**NOTICE OF ADDENDUM AND CLARIFICATION NO. 2
NEW MARGARET AVENUE EXTENSION
OCTOBER 10, 2025
TERRE HAUTE, INDIANA**

3. DELETE: Sheet Numbers PP1 and PP2 from the original plan set.
ADD: Sheet Numbers PP1 and PP2 from Addendum #2.

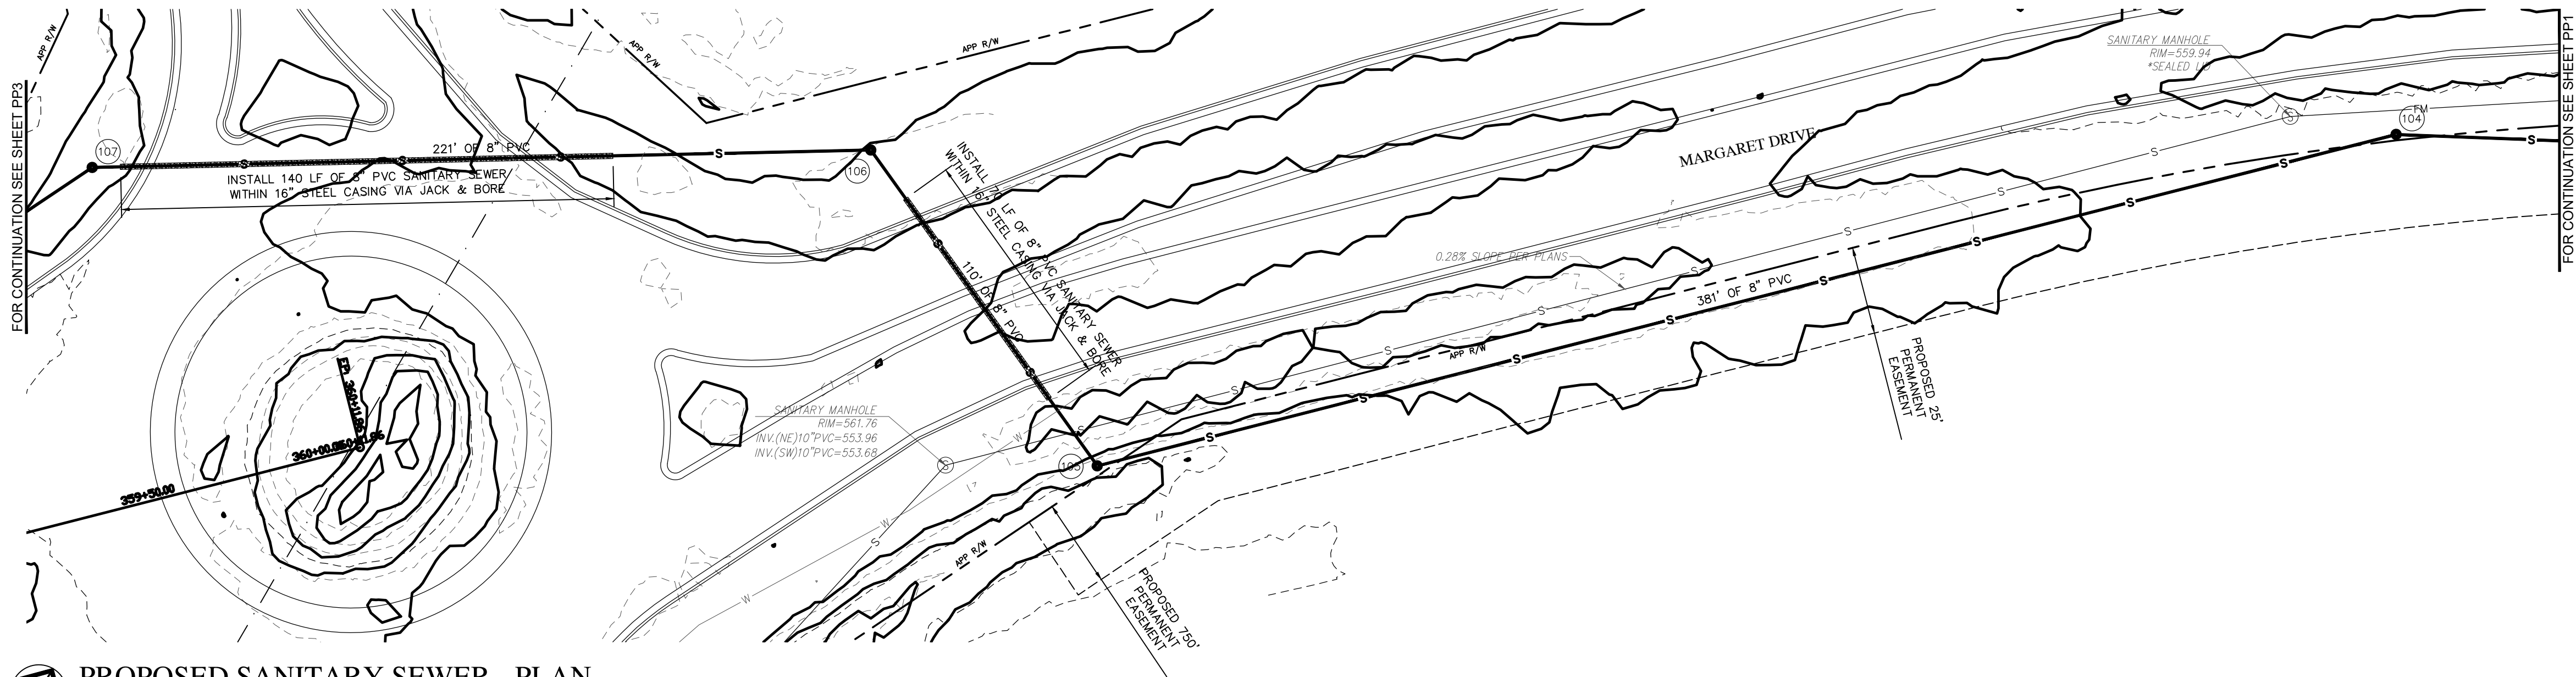
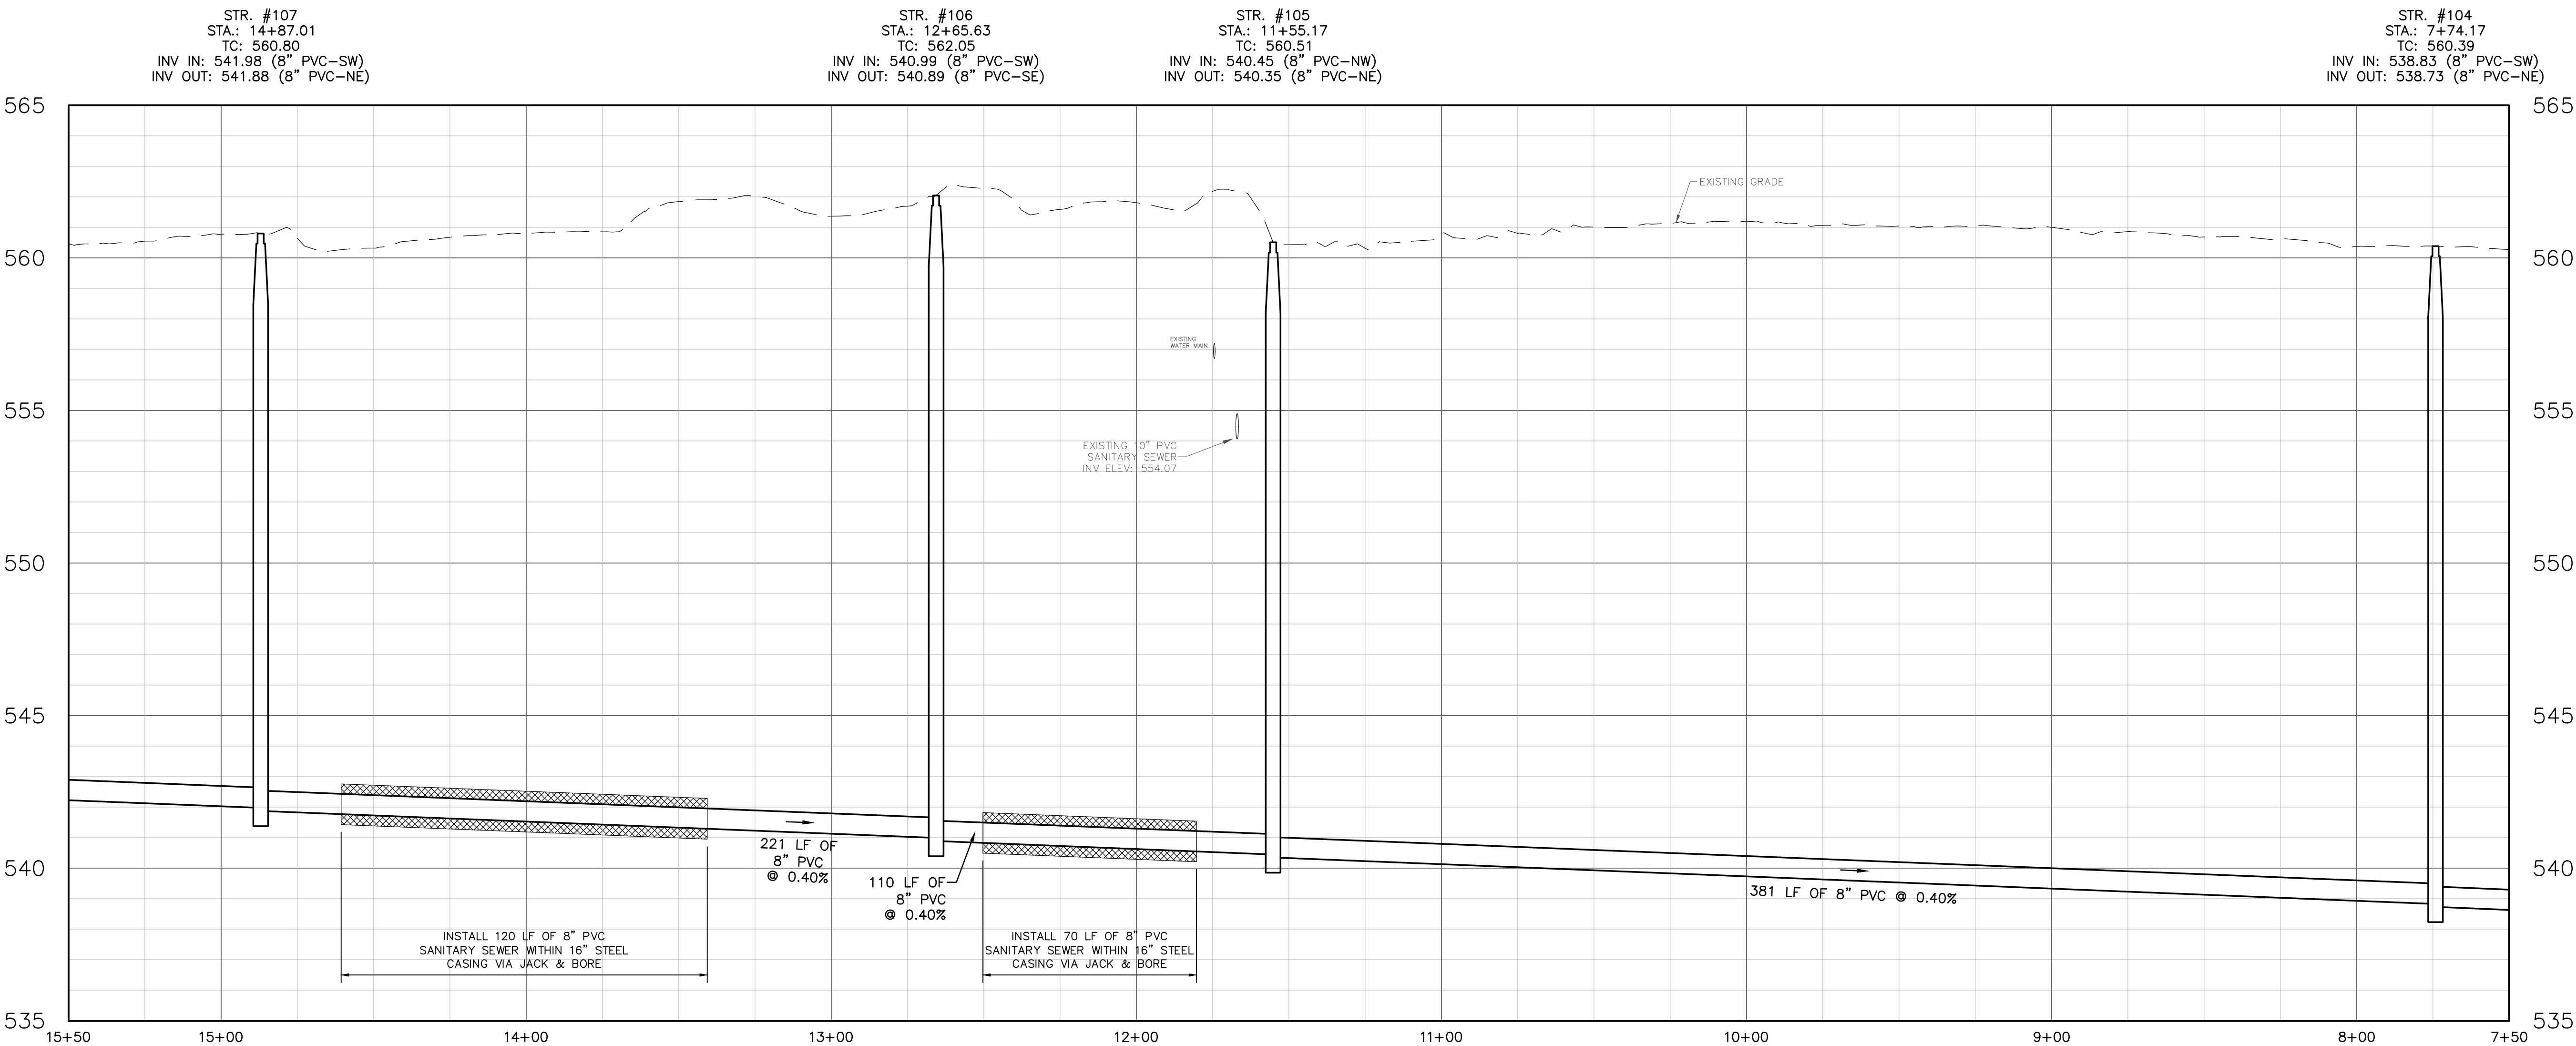
Miscellaneous revisions to sanitary sewers plans based on questions received.
